Modification Recommended Service Note

P5004B Keysight Streamline Vector Network Analyzer

Potential lifted front panel overlay

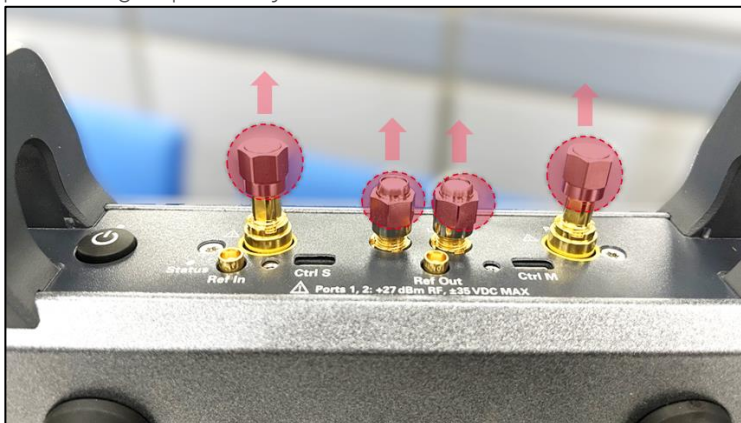
Keysight streamline series vector network analyzer (VNA) of serial number range identified in service note cover page might potentially exhibit the following lifted front panel overlay symptom.

Apart from cosmetic imperfections, the lifted front overlay could have led to non-fully attached *Ctrl S* micro-HDMI cable connector in multi-VNAs setup configuration.

-> Apply this service note only if end users' VNA is exhibiting the following symptom.

Procedure to replace the front panel overlay.

1. Remove the front handles. Detach the 50-ohm termination (LO-In, LO-Out, Port 1 & Port 2) or protecting caps if they are attached to the VNA.

2. Pry open the existing front panel overlay and remove it from front panel.
3. Clean the metal surface thoroughly and ensure it is free of adhesive residue.
4. Affix the new self-adhesive front panel overlay onto the metal surface.
5. Reinstall (reuse) the 50-ohm terminations and port protecting caps accordingly.

6. Reinstall (reuse) the front handles.
